TECHNICAL BULLETIN TB06-2020

Jotron EPIRBs have been issued new Cospas-Sarsat TAC numbers (Approval numbers) which require new Software to be used when programming.

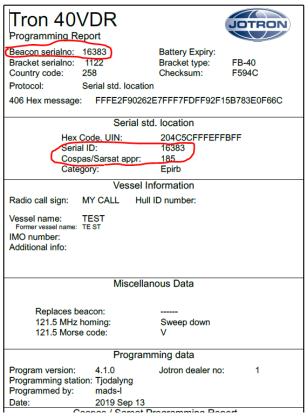
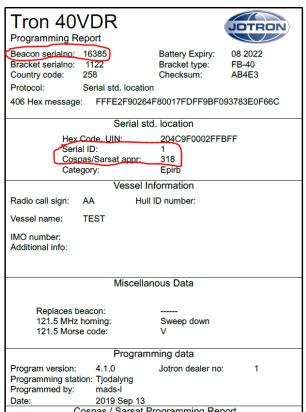
See example below showing the difference between the last Tron40VDR coded with Cospas-Sarsat approval no 185 (TAC no), and first coded as no 318. Note that on the programming report the actual serial number of the EPIRB is shown on line 3, and actual coded Serial ID is shown on the second redline marking below.

So for serial number of 16385 and higher, the labeled serial number on the unit and the encoded are not the same, but can easily be found by adding 16384 to the encoded serial number.
